# UNITED STATES PATENT AND TRADEMARK OFFICE

APPLICATION NO.	FILING DATE	FIRST NAMED INVENTOR	ATTORNEY DOCKET NO.	CONFIRMATION NO.
10/687,933	10/20/2003	Helmut D. Link	246472006000	8319

<b>Office Action Summary</b>	<b>Application No.</b> 10/687,933	<b>Applicant(s)</b> LINK, HELMUT D.	
	<b>Examiner</b> David Comstock	<b>Art Unit</b> 3733

### **DETAILED ACTION**

Figure 1

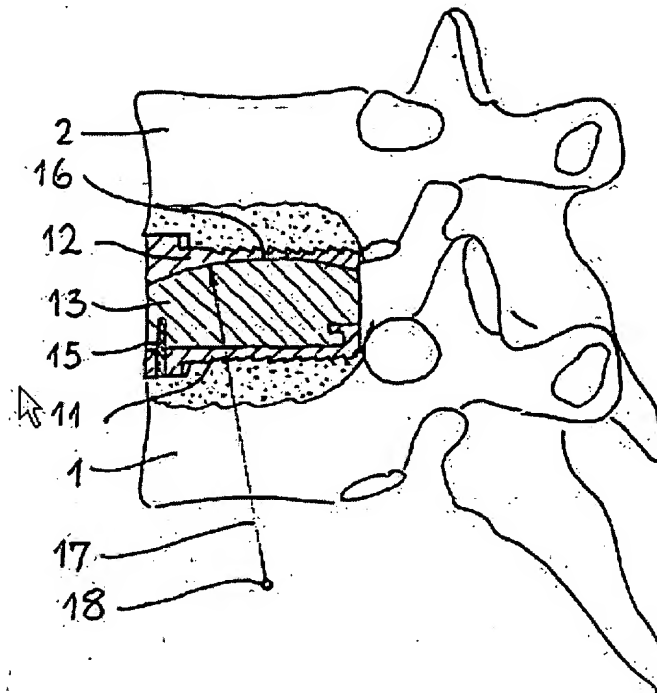
The drawings are objected to under 37 CFR 1.83(a) because they fail to show the "hinge radius" as described in the specification. Any structural detail that is essential for a proper understanding of the disclosed invention should be shown in the drawing. MPEP § 608.02(d). Corrected drawing sheets in compliance with 37 CFR 1.121(d) are required in reply to the Office action to avoid abandonment of the application. Any amended replacement drawing sheet should include all of the figures appearing on the immediate prior version of the sheet, even if only one figure is being amended. The figure or figure number of an amended drawing should not be labeled as "amended." If a drawing figure is to be canceled, the appropriate figure must be removed from the replacement sheet, and where necessary, the remaining figures must be renumbered and appropriate changes made to the brief description of the several views of the drawings for consistency. Additional replacement sheets may be necessary to show the renumbering of the remaining figures. Each drawing sheet submitted after the filing date of an application must be labeled in the top margin as either

First, by way of clarification of terminology used by Applicant, the following is noted. Figure 1 of Applicant's invention, reproduced below, shows *slide surface radius* 17. The slide surface radius extends from the *center of hinge movement* 18 to the slide surface. Thus, slide surface radius is inextricably defined with respect to the center of hinge movement. Therefore, it necessarily follows that if the different prostheses have different slide surface radii of curvature (which they do in Berry, as set forth above), they must also have corresponding different centers of hinge movement. Therefore, any argument that Berry does not disclose "centers of hinge movement" is without merit.\*\*

\*\* It is noted that "*hinge radius*" is another measurement and is not set forth in the remaining rejected claims and should not be confused with *center of hinge movement* or *slide surface radius*. However, even if *hinge radius* were in the claims, again, it would inherently be set forth, since it is defined as the distance from the *center of hinge movement* to the geometric midpoint of the prosthesis.
